Municipal Planning Commission

AGENDA

City of Bartlett, Tennessee Municipal Planning Commission Staff Report

SUBJECT: Master Plan Application Review

SHEET 1 of 1			
DIVISION OF ENGINEERING			
UTILITY PLAN			
LOCATION: 7642 SUMMER AVENUE			
SURVEY	TRF	DATE	10/22
DRAFTED	EKM	DATE	2/23
DESIGN BY	TRF	DATE	2/23
REVIEWED		CHECKED	DATE
CITY ENGINEER		DATE

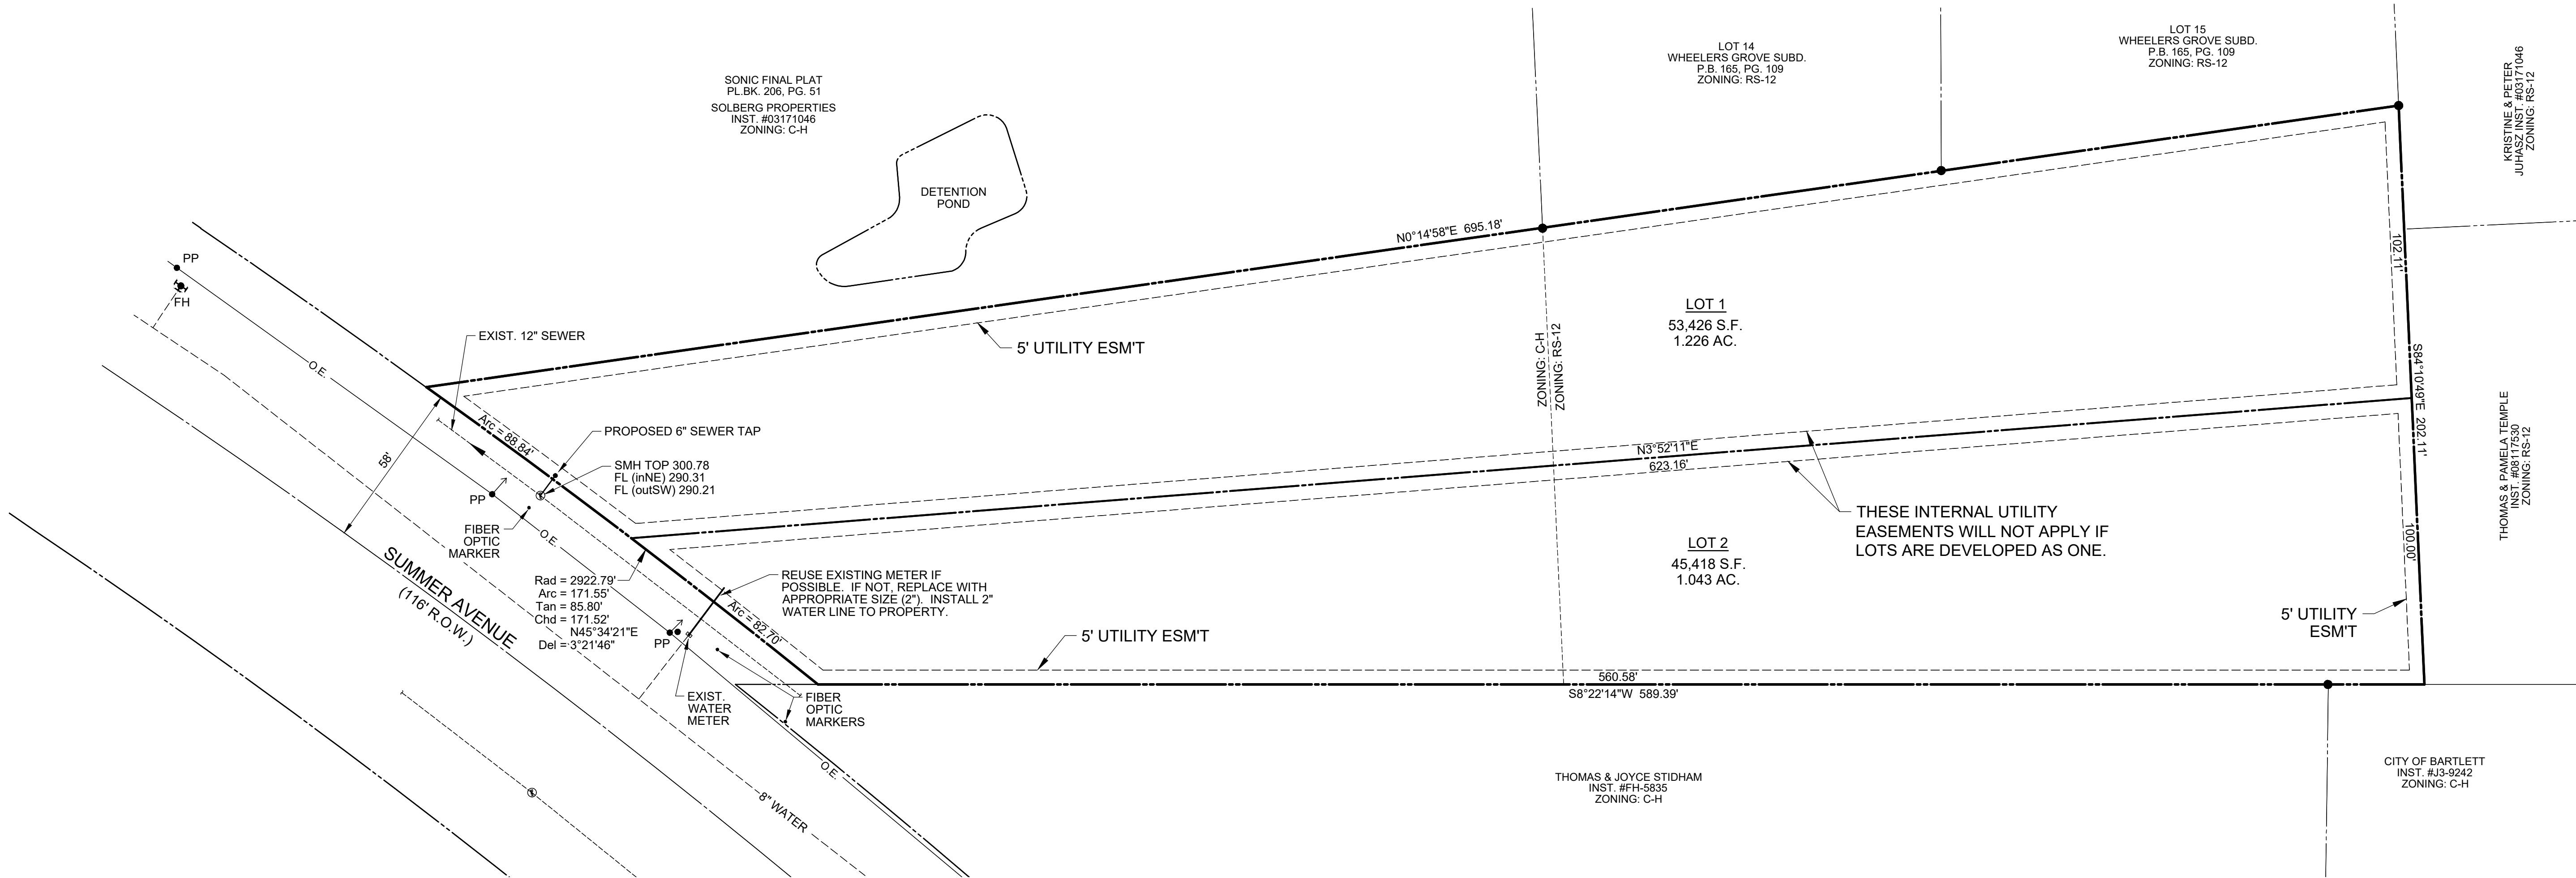
9. If any sewer cleanout is located in a paved area, then it shall comply with the detail approved by Bartlett Codes which involves a brass connections and a concrete collar.
10. Proposed Sewer service appears to be in the proposed detention basin.
11. There appears to be an existing sewer service on the existing conditions plan that is not shown on the utility plan. Since this project is located in the Fletcher Creek Sewer Basin, if an existing sewer service cannot be found, approval will be dependent on developer receiving written approval from the City of Memphis for new sewer connection and possible sewer holding tank.

12. Tracer wire must be installed on all sewer lines, including services.
13. If a 2" water service is required, the existing 8" water main will need to be tapped. A separate irrigation tap will also be required. The existing water service may be adequate for this irrigation but will need to be re-located out of ROW and adjusted to grade. Traffic control plan will be required along with any TDOT permits.

GRADING and DRAINAGE PLAN
LOCATION: 7642 SUMMER AVENUE

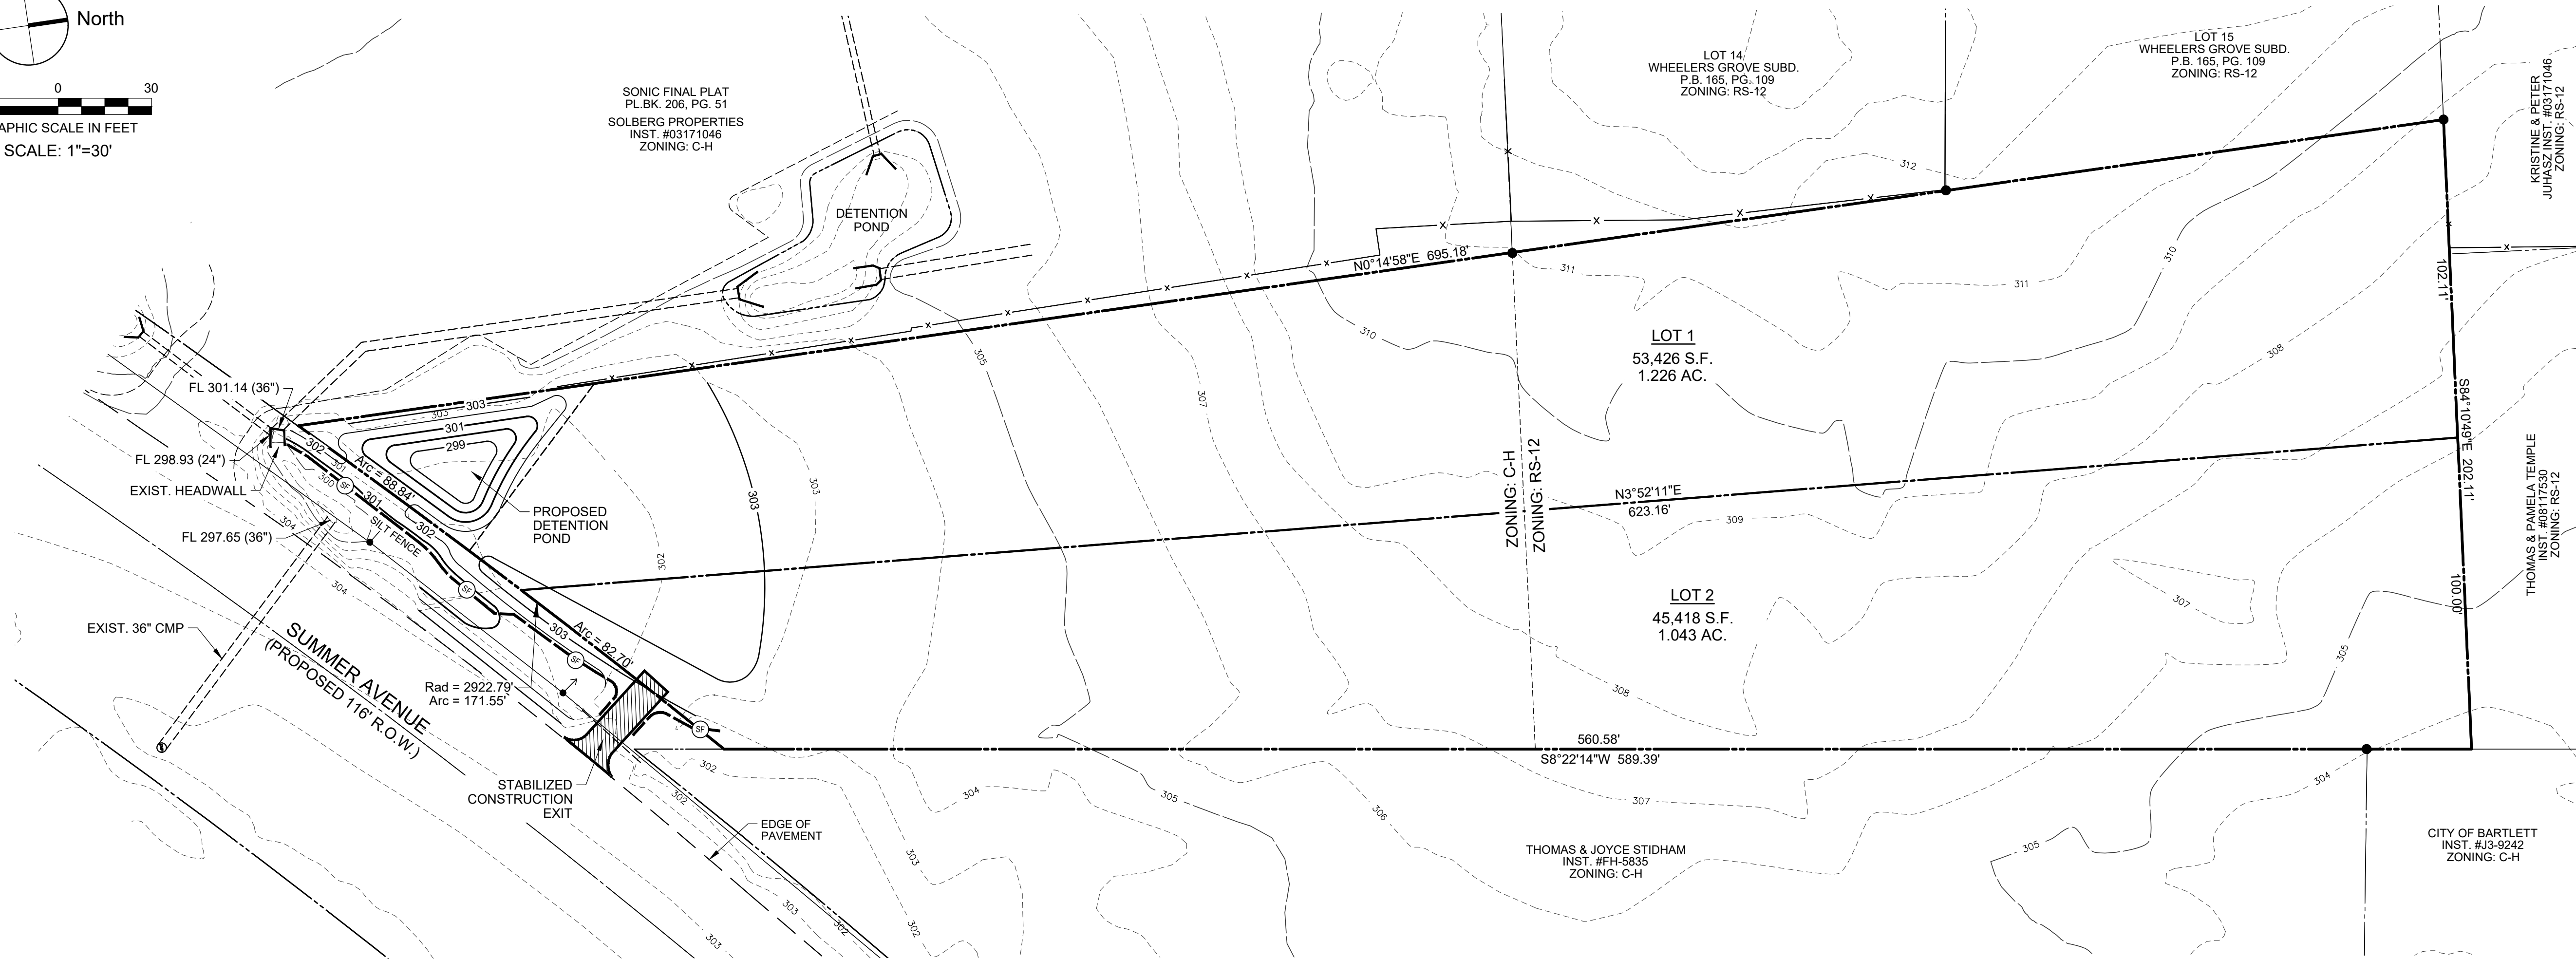
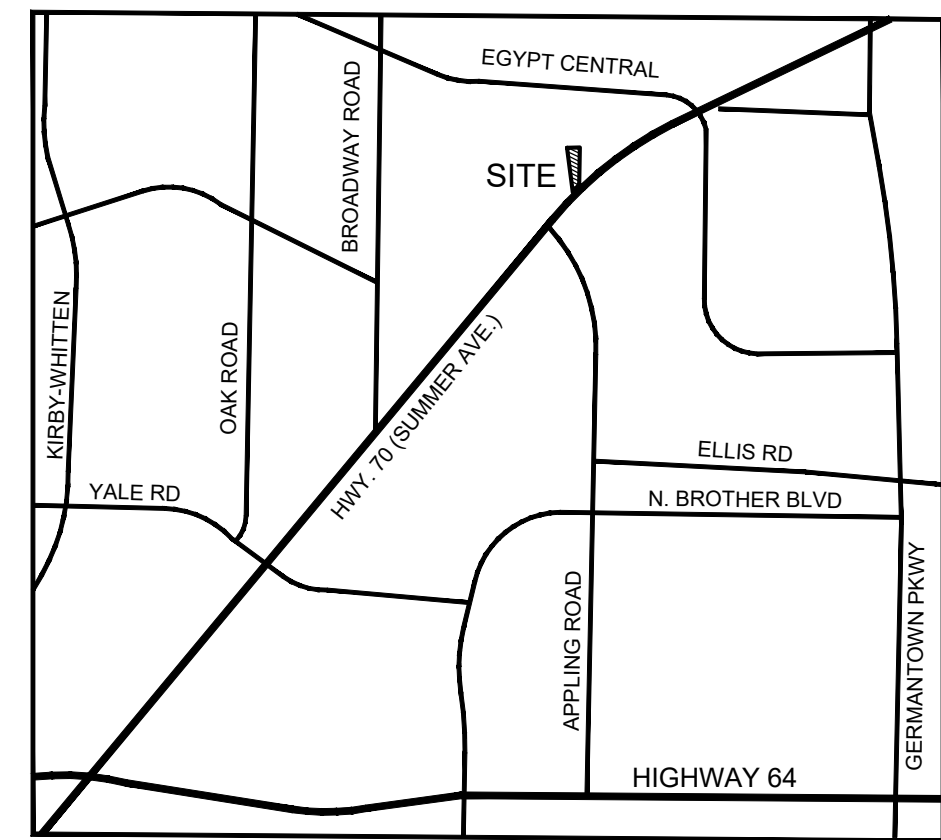
18. No drainage or outlet control structure for detention basin are shown.
19. Additional elevation points, grades, and cross-sectional slope sections, coming from the existing centerline and including the new deceleration lane shall be added. Cross slope transition and positive road drainage shall be maintained.
20. Deceleration lane shall transition to existing slope at no greater than a 4:1 slope.
21. Plan and profile will be required for the road improvements.
